ADDENDUM NUMBER 2

Project Number 64009001; Federal No. STP 3301 (404)

Project Title Town of Kansas Site Fencing

ISSUE DATE: November 18, 2011

CHAIN-LINK FENCE

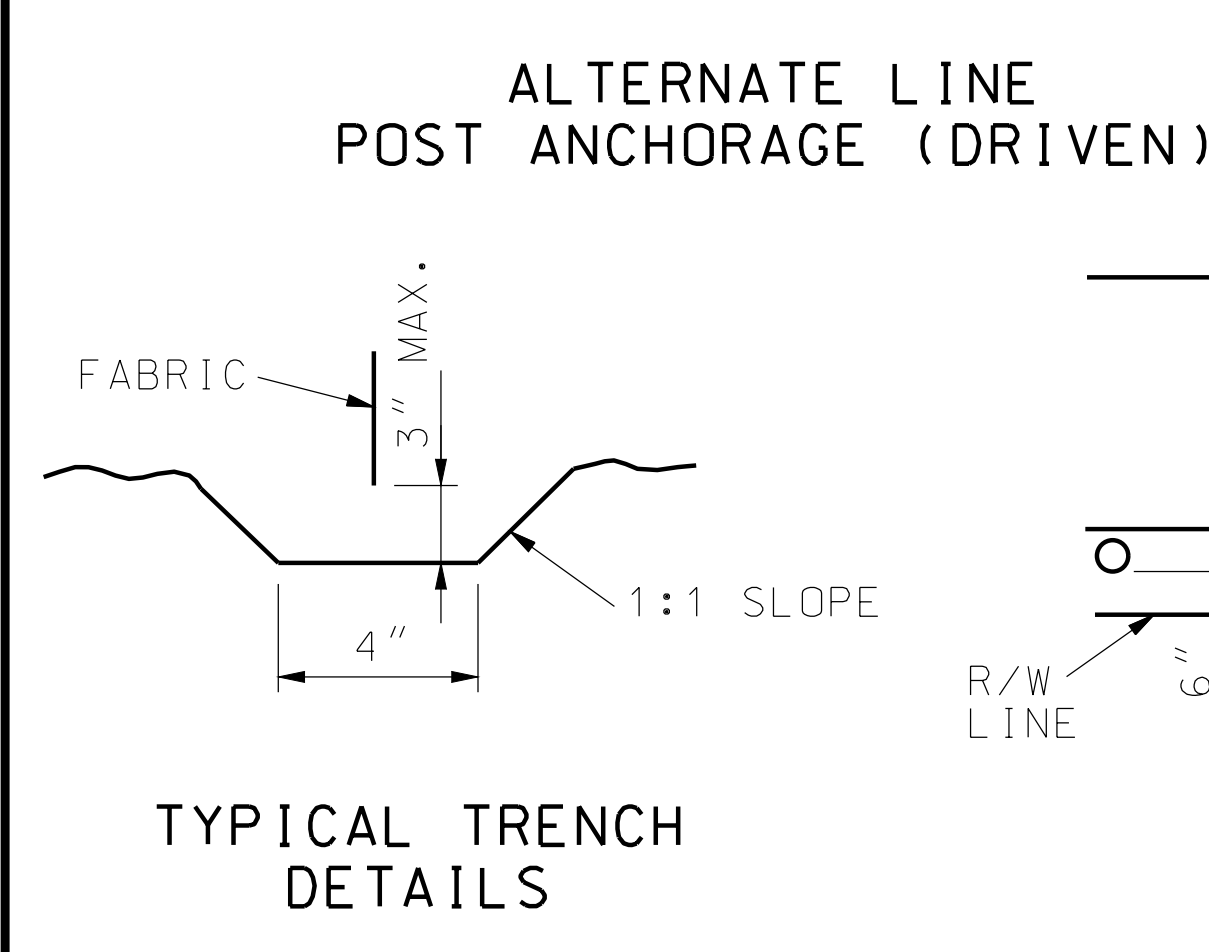
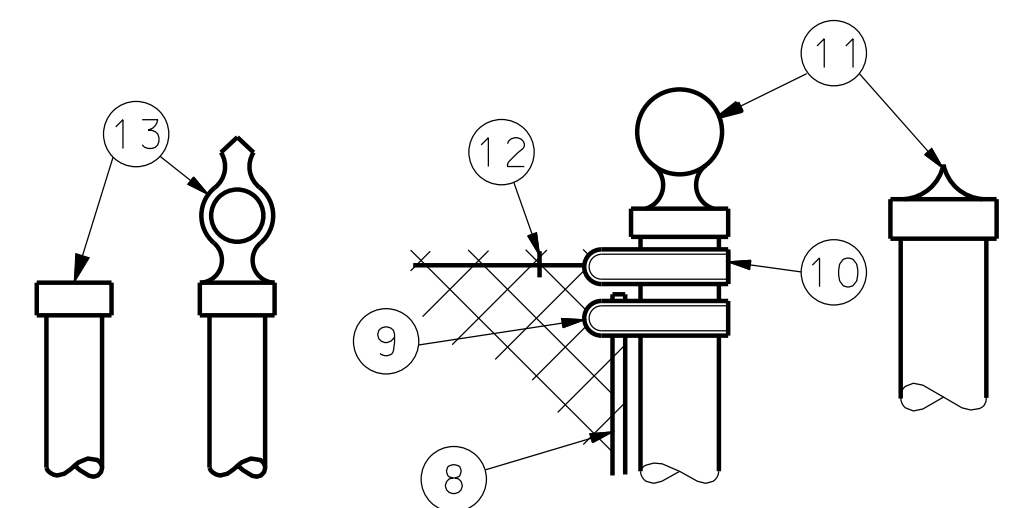
1. MODOT Standard Drawing 60710V is hereby provided. This drawing was to be included as page 02308-3 of Section 2308 – Fencing – of the Specifications for the project.
